**Radon in Natural Gas from Marcellus Shale**  
**By Marvin Resnikoff, Radioactive Waste Management Associates**  
**Executive Summary\***  
**January 10, 2012**

The Draft Supplemental Environmental Impact Statement produced by the New York State Department of Environmental Conservation needs to be revised to take into account this public health and environmental hazard. In the entire 1400 page statement there is only one sentence containing the word “radon” and no consideration of this significant public health hazard.

Figure 1. Excerpts from Gamma Ray Logs for (a) Shiavone 2 Well (Reading); (b) WG111 Well (Dix); (c) Bergstresser Well (Pulteney)

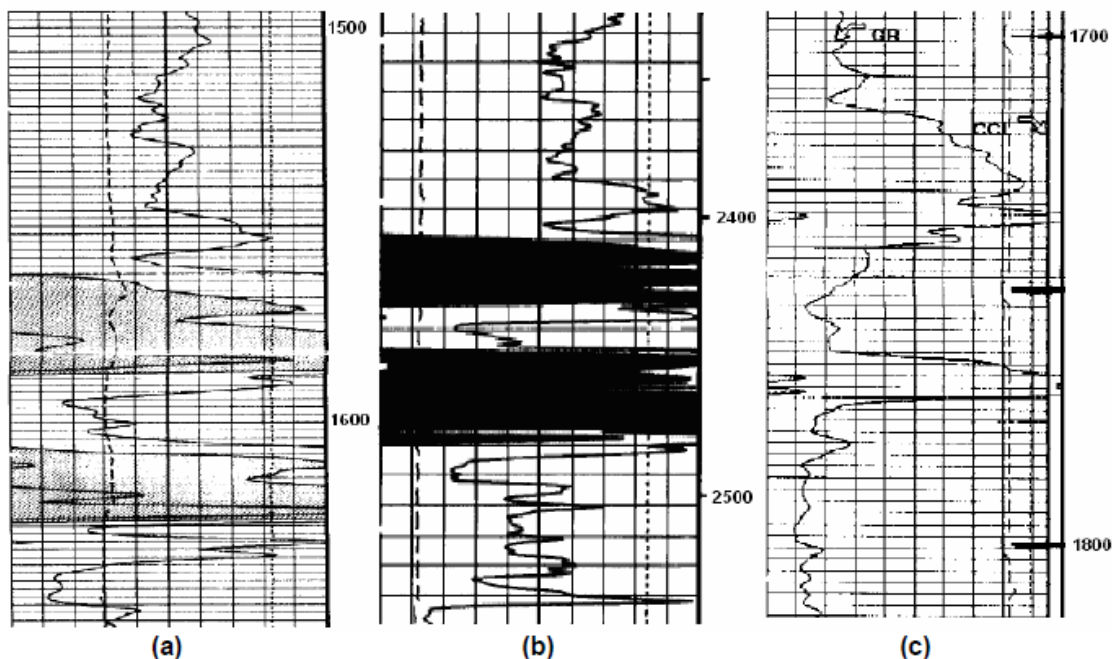
In exploring for gas and oil in shale, the industry identifies natural gas formations by the high radioactivity and high carbon content at the Marcellus Shale horizon. Within the Marcellus Shale formation, the radioactive concentrations are 20 to 25 times background. However, the New York Department of Environmental Conservation (DEC) claims that “black shale typically contains trace levels of uranium and gamma ray logs indicate that this is true of the Marcellus shale.”<sup>10</sup> Based on gamma ray logs, a study by the United States Geological Survey and statements in the Draft Supplemental Environmental Impact Statement, we differ strongly with the DEC assessment that the concentrations are “trace levels.”

All logs have a provision for the shifting of scale from the standard 0-200 GAPI range to greater than 200 GAPI or even greater than 400 GAPI. It is unclear from the logs how the shifting of scale is recorded, but at a certain depth the gamma ray line indicates measurements beyond the 0-200 GAPI range (Figure 1).

The measurements beyond the 0-200 GAPI range are found at the following depths: In the well log for the Reading, NY well (Shiavone 2), this occurs approximately between 1550 and 1650 feet, in the well log for Dixon, NY (WG111) this occurs between 2400 and 2500 feet, and in the log for the Bergstresser well in Pulteney, NY we see it between 1700 and 1800 feet. These sections of increased radioactivity represent the Marcellus shale.

In each case the thickness (less than 100 feet) and the depth of the shale is consistent with the general geological predictions of the Marcellus formation in the region. It is not possible to give the specific radioactivity measurement due to the log quality, but if we consider that these sections indicate the gamma ray range of 200-400 GAPI, it would represent radioactive radium concentrations of about 12-24 pCi/g or higher. These radium concentrations are far higher than background radium concentrations in New York State<sup>14</sup>, which are 0.85 pCi/g.
